October 17, 2018

Re: **Park Road Corridor Traffic Calming Safety Improvements**

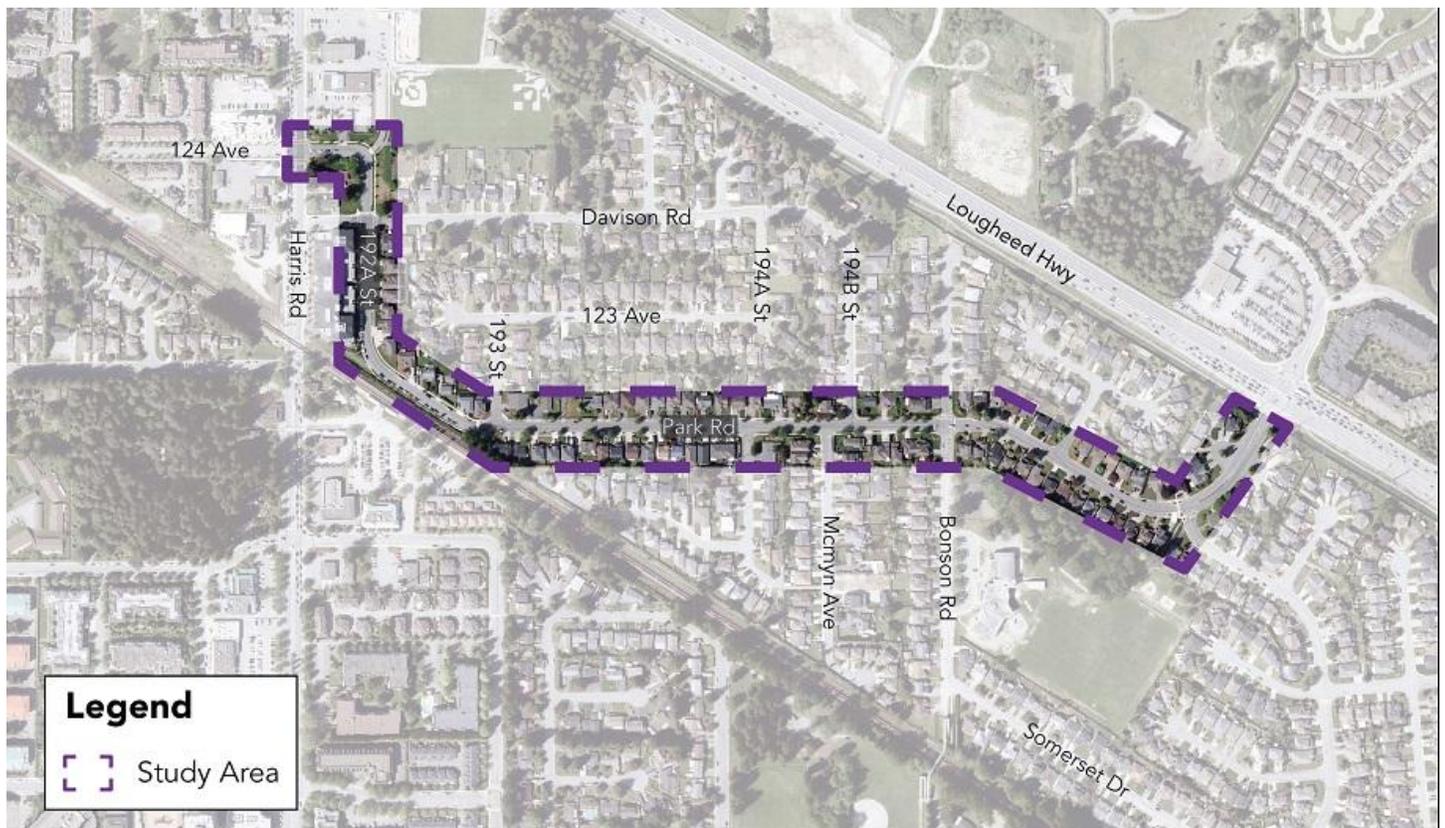
Park Road is an important neighbourhood bikeway which connects from Maple Ridge via Meadowtown Mall to Harris Road and beyond to the Pitt River Bridge:
